Access Compliance Report Public Rights-of-Way (Curb Ramps)

Main Street: RAINIER_DR Cross Street: KOOTENAY_DR Location: NE

ADA ID: RPAT211001100557 Ramp Type: Type 6 - Directional 1 Initial Pass/Fail: Fail Overall Compliance: No Severity Score: 2

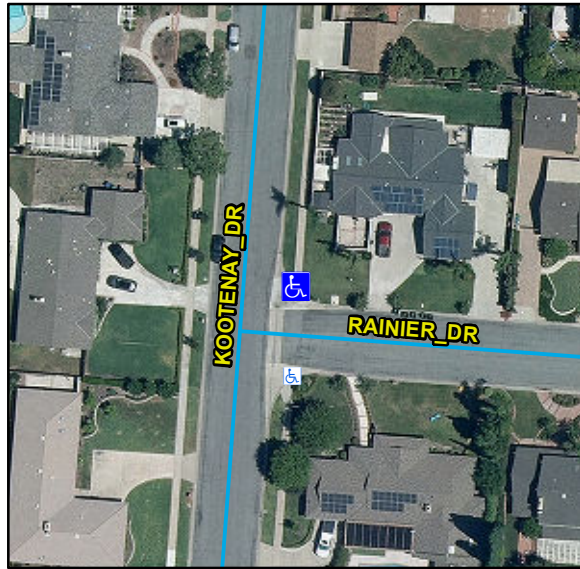
Compliance	Description	Data	Compliance	Description	Data
N/A	Ramp Length (in)	117	N/A	Flare Type LT	
Yes	Ramp Width (in)	50			N/A
Yes	Ramp Run Slope (%)	7.8	N/A	Flare Slope LT (%)	N/A
No	Ramp Cross Slope (%)	3.2	N/A	Flare Traversable LT	N/A
N/A	Grade Break	N/A	N/A	Flare Type RT	
N/A	Grade Break Slope (%)	N/A			N/A
N/A	Grade Break Cross Slope (%)	N/A	N/A	Flare Slope RT (%)	N/A
	Addl Para Ramp Left?	No	N/A	Flare Traversable RT	N/A
	Addl Para Ramp Right?	No	N/A	DWS Provided	N/A
N/A	Landing Present	N/A	N/A	DWS Contrast	N/A
N/A	Landing Length (in)	N/A	N/A	DWS Length (in)	N/A
N/A	Landing Width (in)	N/A	N/A	DWS Full Width	N/A
N/A	Landing Run Slope (%)	N/A		DWS Offset Type	N/A
N/A	Landing Cross Slope (%)	N/A	N/A	DWS Left Offset (in)	N/A
N/A	Landing Movement Obstructed?	N/A	N/A	DWS Right Offset (in)	N/A
	Landing Movement Type	N/A			
N/A	Landing Shared	N/A			
N/A	Marked Crosswalk 1	No	N/A	Clear Space	N/A
	Crossing 1 Direction	S	N/A	Clear Space To Crosswalk (in)	N/A

Remove & Replace Entire Ramp.

R304.5.3, STD 1115
